DEVELOPMENT PLAN

Re: Development Plan Review: 145 W Pearl Ave, Jackson, Wy; 65 S Glenwood St, Jackson, Wy

Responses to Sketch Plan Review Comments (6.18.2025)

PEARL STREET CURB & SIDEWALK PROFILE
 HORZ SCALE: 1" = 10'
 VERT SCALE: 1" = 5'

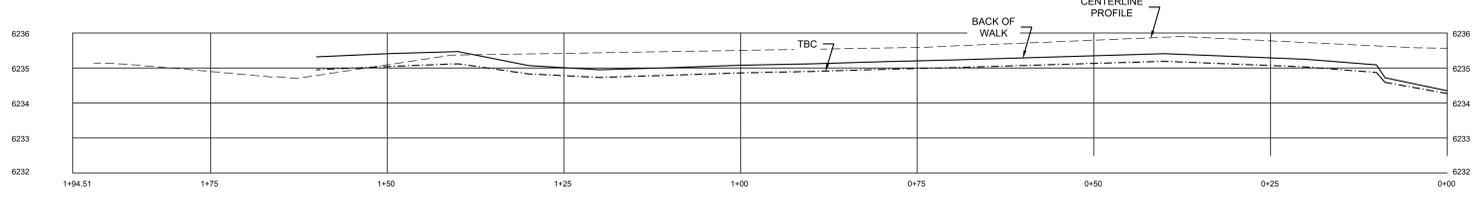
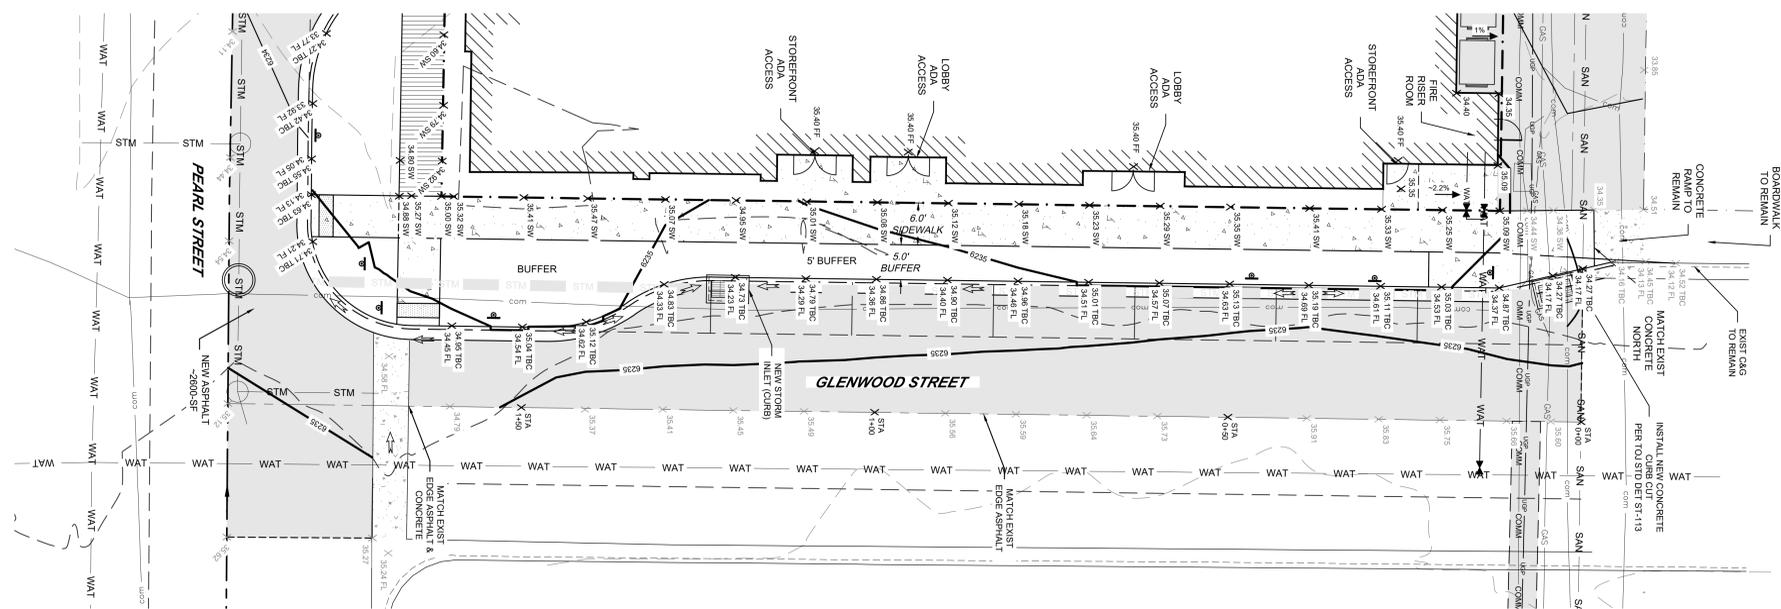
12. Show how new building and grading within private property will tie into the public right-of-way. Do not use sidewalk/buffer area to make up grading for private project. Include profile drawing(s) of existing and proposed top back of curb, flowline, and back of sidewalk.

Responses: Grading plan (draft) provided. No grading proposed on adjacent properties.

GLENWOOD STREET CROSS SECTIONS

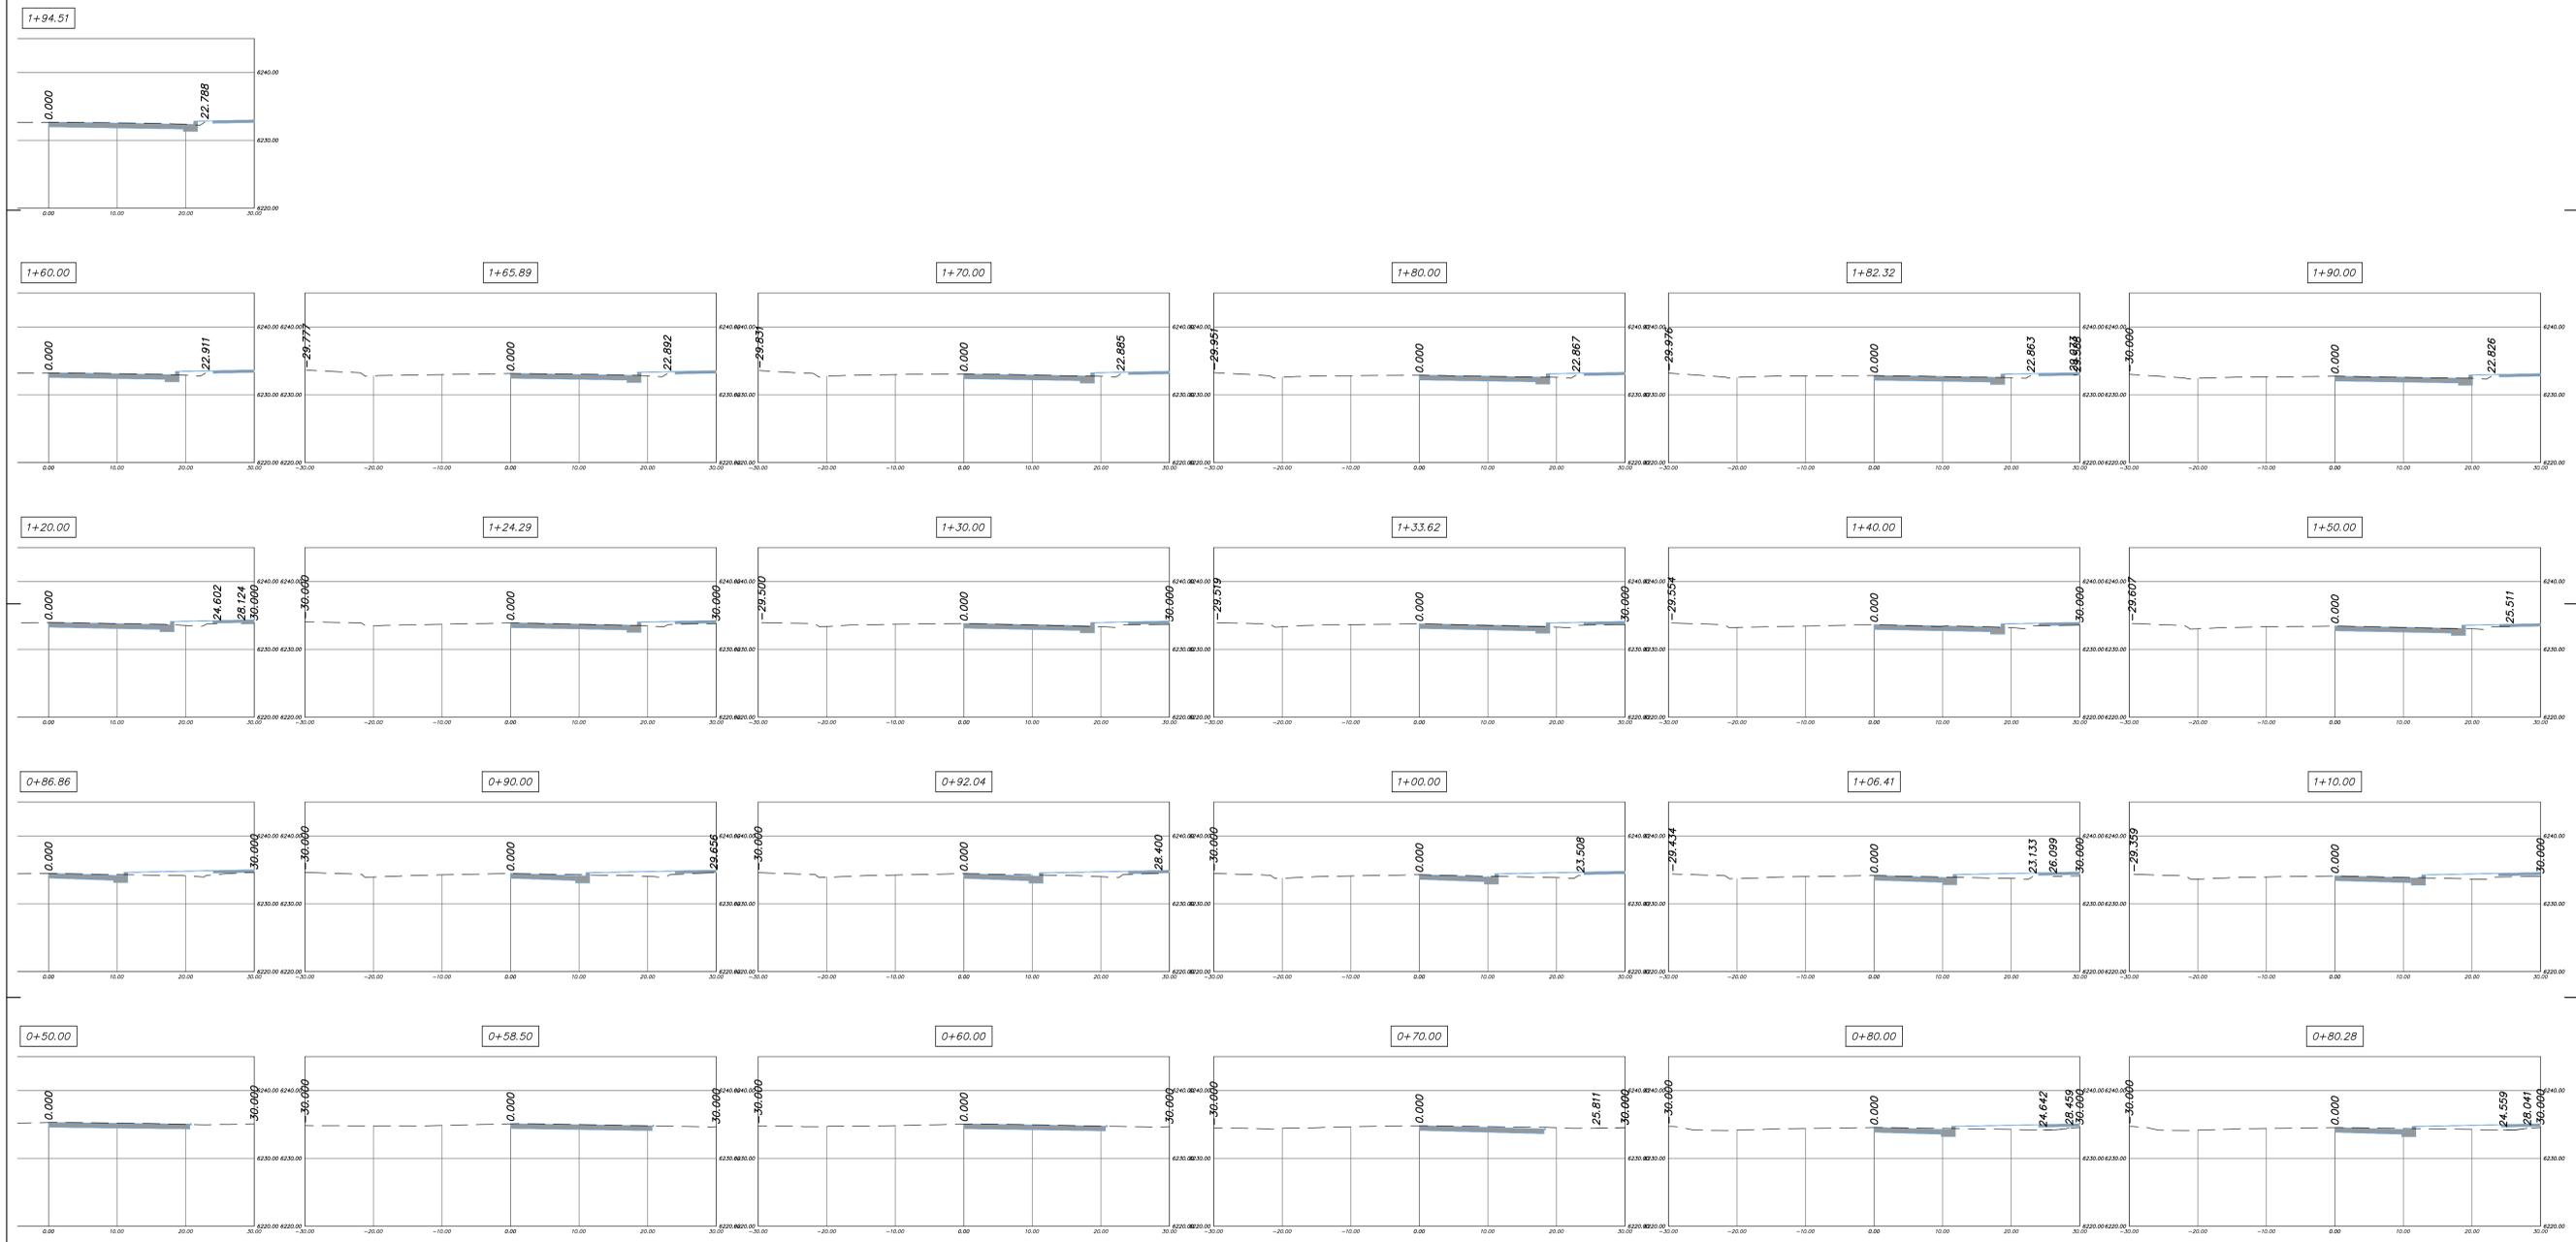
16. Provide existing and proposed cross sections of the Pearl and Glenwood right of ways and pedestrian frontages. Proposed sections and frontages should conform with the Community Streets plan.
